April 2019
FL807A-D
NHTSA #19V-093
Transport Canada #2019-066

Subject: Hendrickson 5 Inch Drop Axle Tie Rods

Models Affected: Specific Freightliner Cascadia vehicles manufactured April 30, 2012, through May 26, 2015, equipped with Hendrickson 5 inch drop axle tie rods, brake linings, and stamped spiders.

Fig. 1, Tie Rod Assembly

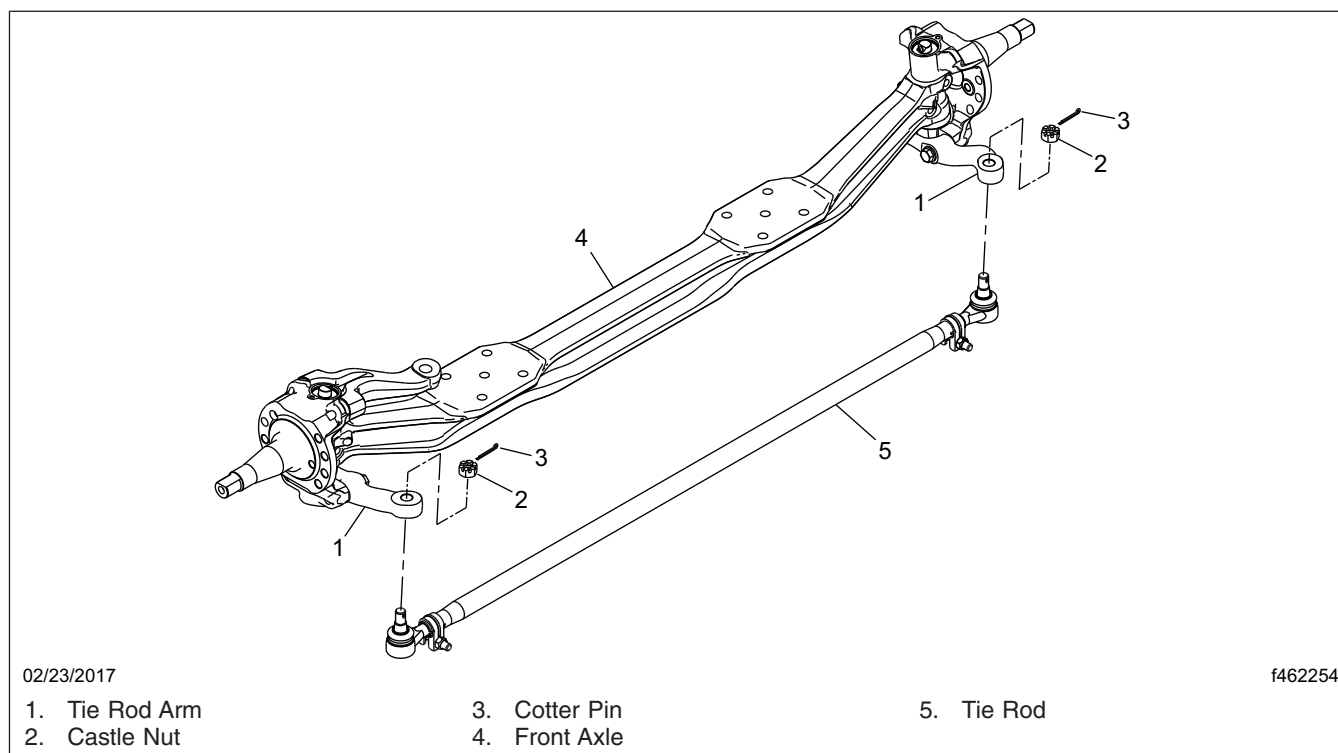
6. Remove the brake assembly. Refer to the applicable section in **Group 42** of the *Cascadia Workshop Manual*.
7. Disconnect the tie rod from the tie rod arms; see [Fig. 1](#). Remove the tie rod from the vehicle and discard it.

8. Attach a new tie rod to the tie rod arms. Tighten the castle nut 120 to 170 lbf-ft (163 to 230 N·m) plus a maximum of one-sixth of a turn to align a slot in the castle nut with the cotter pin hole in the tie rod stud. Insert the cotter pin and bend the tangs to secure it.
9. Clean and inspect all brake parts that will be reused. Refer to the applicable section in **Group 42** of the *Cascadia Workshop Manual*.
